**CITY OF ISSAQUAH**  
**MAJOR DEVELOPMENT REVIEW TEAM**  
**URBAN VILLAGE DEVELOPMENT COMMISSION**

**STAFF REPORT**

File No.: SDP 09-002IH  
Project: Issaquah Highlands  
Block 24 Site Development Permit

Missing segments of the sidewalk and trail system; see drawing above for Legend

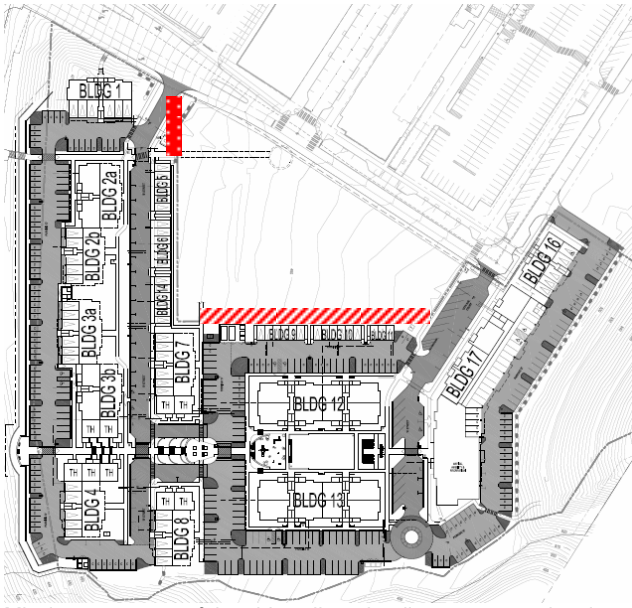
The above diagram represents the plan with necessary modifications to comply with pedestrian orientation. The modifications are:

- orienting all main building entries to sidewalks (associated with streets, discussed below in *Appendix H, Urban Roads*) or trails (regulated by and discussed below in *Appendix T, Trails*). Contrary to the application, buildings may not have main entrances from parking lots as that is not pedestrian but car oriented. For instance, all the carriage units (Buildings 5, 6, 9, 10, 11, 14) shall have their entrances facing Lot 1. Buildings 7 and 8 shall have their main entrances on the east from a trail. However, secondary entrances may be located on parking lots.
- adding, or extending to, sidewalks and trails to complete the necessary connectivity, allowing a pedestrian to travel to and from outside pedestrian routes (e.g. Discovery Drive, pedestrian bridge) to the main building entrances via sidewalks or trails. **[Condition 7]**

New trail connecting Overlook with pedestrian bridge between retaining walls; see drawing above for Legend

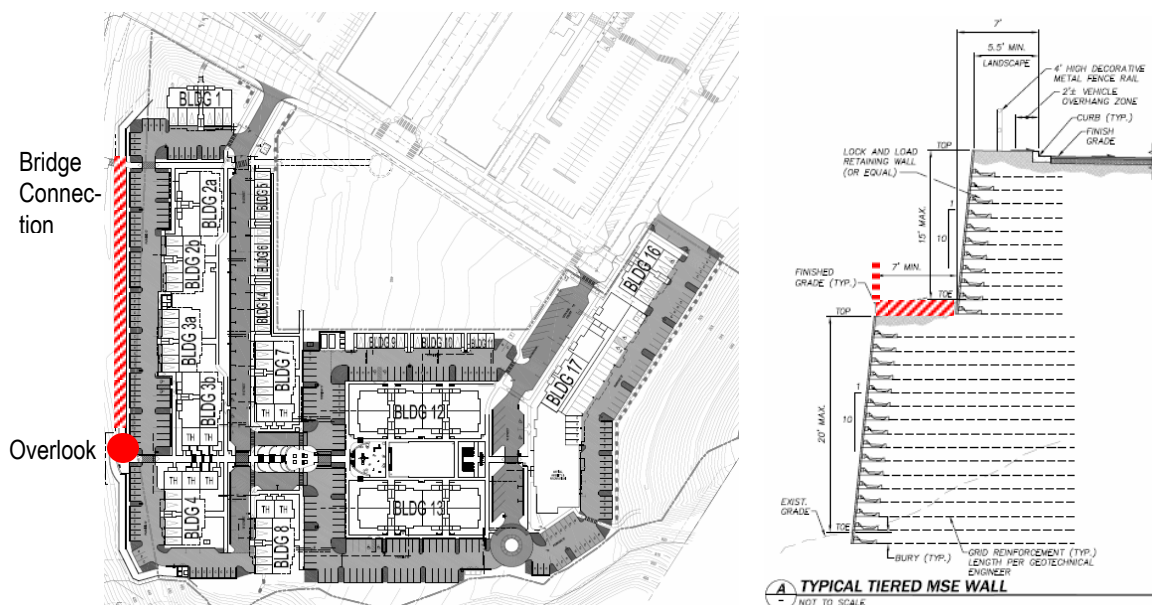
A pedestrian friendly community also provides pedestrian connections where people will want to go. Currently no connection is provided from the Overlook, at the west end of the Pedestrian Spine, to the pedestrian bridge. If pedestrians see one from the other, the only way to walk to it is via the parking lot. As mentioned above, having no choice other than a parking lot to connect between places pedestrians will reasonably want to go, is not pedestrian friendly. Staff recommends that the trail connecting the Overlook to the pedestrian bridge be located between the retaining walls (shown below), away from the parking lot. With trailing plants above and decorative handrails, the trail can provide an appropriate pedestrian connection. Other connection routes may be proposed as long as they are separate from the parking lot; a trail separated by a few feet from the parking lot does not meet this requirement. **[Condition 8]** Another trail, between the pedestrian bridge and Discovery Drive and which is ADA accessible, is required by the Preliminary Plat. See *Appendix H, Urban Roads* for more information.

B Street, additional trail crossing between Buildings 7 and 14; see drawing above for Legend

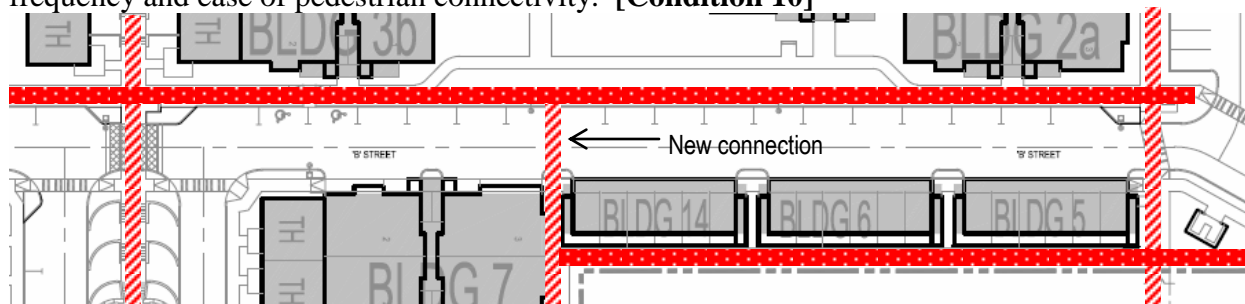
Finally, pedestrian orientation and proximities not only relates to the design of the pedestrian facilities but also their frequency. Sidewalks associated with streets are the primary pedestrian facilities but where there are no streets, trails are provided to create pedestrian connectivity. In general the proposed frequency of pedestrian facilities is good. However with the sidewalk east of the Carriage Units, a mid-block connection to the western sidewalk is necessary given the length of that block and inconvenience of the southern connection; providing an additional connection at one of the breaks between Carriage Units will provide a more appropriate frequency and ease of pedestrian connectivity. **[Condition 10]**

Non-residential Street as proposed in SDP (Sht A-10, excerpt)

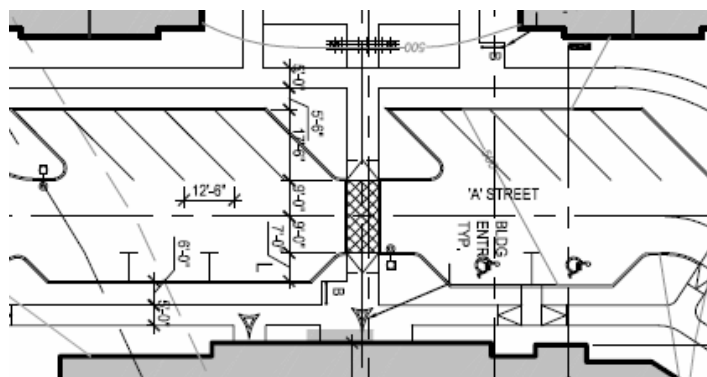
10<sup>th</sup> Avenue/A Street: This street is proposed as a Non-Residential Street, as approved by AM05-010IH and AM05-011IH. As the name indicates these are not generally for non-residential areas; however, an approval condition allows its use where residential land uses represent 30% or less of the street frontage. From Franklin Drive to the on-site traffic circle, Block 24 comprises 27% of the street frontage, thus the on-site segment may use this standard. To better match the residential setting, AM09-003IH modifies the standard by reducing the travel lanes to 10 ft and the sidewalks to 5 ft. Generally the proposal meets the standard, though slight modifications are necessary; these details will be reviewed with construction permits.

Modified Sub-Collector 2 Street as proposed in SDP (Sht A-10, excerpt)

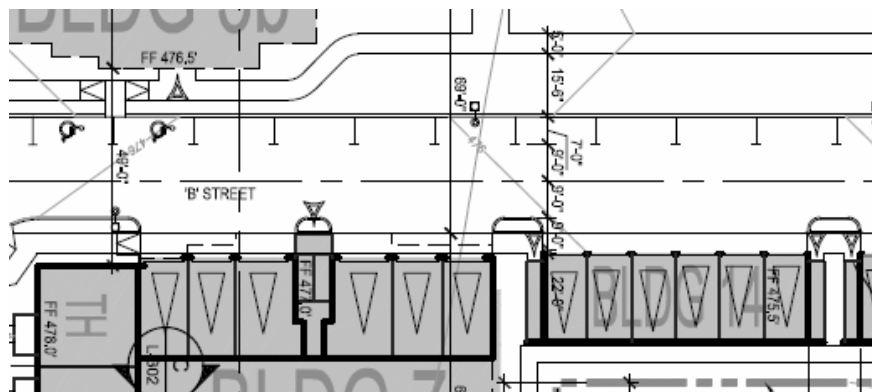
**B Street:** This street is a Sub-collector 2 consistent with an AMM approved for this project, AM09-003IH. There are several details that are inconsistent with the AMM, such as:

- The planter strip widens to more than 15 ft. Though wider planter strips are welcomed in certain situations, in this case it is inconvenient for pedestrians, and thus should not be used.
- The area in front of the garages is wider than the 4 ft required. This is acceptable; however the use of this area as a walkway is not. The walkway shown behind the carriage units is the safe and appropriate location for pedestrians to access residences and walk through the community.

Boulevard Park Street as proposed in SDP (Sht A-10, excerpt)

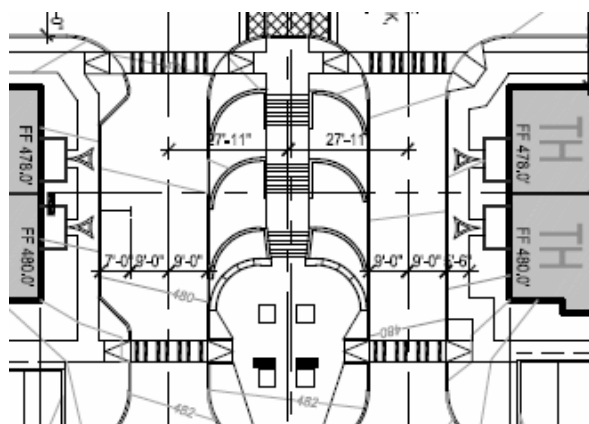
**Boulevard:** The block between Buildings 7 and 8 is designed as a boulevard. This is an excellent use of the boulevard with the Pedestrian Spine in the median. However, there are several aspects of the proposal that aren't consistent with the standard:

- In the application, no planting strips are shown; planting strips should be present and 4 ft wide.
- Travel lanes in the proposal are 18 ft wide with an additional 7 ft parking bay on one segment; instead, the combined travel lane parallel parking are 20 ft wide, preferably with the parallel parking adjacent to residences and the sidewalks.
- The median of the adopted standard is 62 ft wide to accommodate recreational activities, while the proposal's median is about 38 ft wide. AM09-003IH allows reduction of the median; in addition, further minor reductions in the median width may be necessary to accommodate the other elements as specified in the standard. However, the width of the median shall remain substantial and provide a grand setting, consistent with the Feature Pedestrian Way and Pedestrian Spine shown in this application. **[Condition 34]**

Traffic Circle as proposed in SDP (Sht A-10, excerpt)

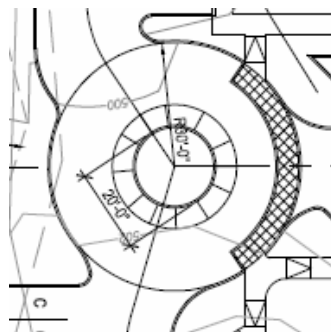
**Traffic Circle:** A Street ends in a traffic circle with a center island. This turnaround is a smaller diameter than the adopted standard, but the diameter appears functional. The diameter and fire truck type will be confirmed at Utility Permit. In addition, while reviewing fire and garbage truck turning radii, it will be determined if landscape material may be placed within the center island and if the ring around the island is necessary for fire or garbage truck maneuvers. The results of this analysis will determine what type of curbing (vertical, rolled, or none) is appropriate between the driving surface and the ring. Finally, to ensure non-service, vehicular traffic drives slowly, the ring around the center of the traffic circle, shall be constructed in concrete or other non-asphalt material to create the perception of a narrow road. **[Condition 35]**

Relocation of transformer to provide better screening (Sht C4.02, excerpt)

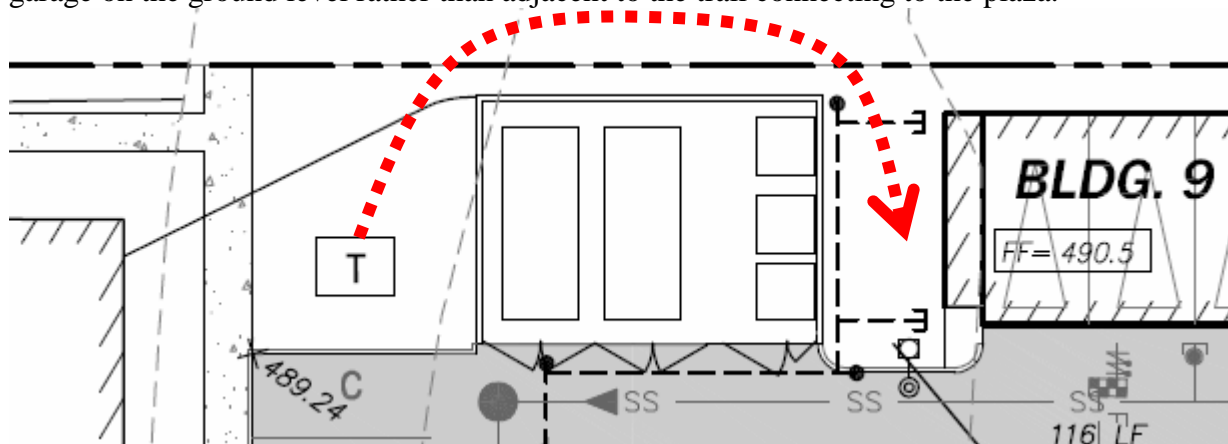
Access and equipment associated with wet and dry utilities are a necessary part of a functioning community. However, their presence does not enhance the overall project character and objectives. Screening and location can reduce the impact of these necessary elements.

**[Condition 55]** For instance the transformer shown between Building 7 and the waste enclosure, could be better screened by placing it between the waste enclosure and Building 9 which has a garage on the ground level rather than adjacent to the trail connecting to the plaza.

Elevational relationship of Block 24 buildings, especially roofs, to adjacent blocks (Sht L-301, excerpt)

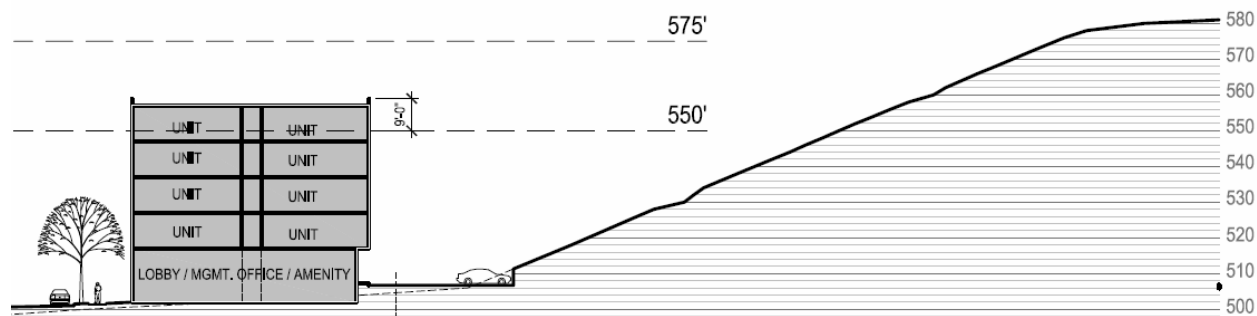
Both mechanical equipment on the ground and equipment on the roof should be screened once the appropriate location is identified. Roof equipment should be screened both for views from the ground but also views from above consistent with minimizing their visual presence. The intent is to screen the mechanical equipment from the buildings' upper floors or buildings which are at higher elevations. Study of the sightlines is necessary to determine what type of screening

is necessary. However, as buildings on the parcels east of the project are much taller, roof equipment will likely need screening from above. **[Condition 56]**
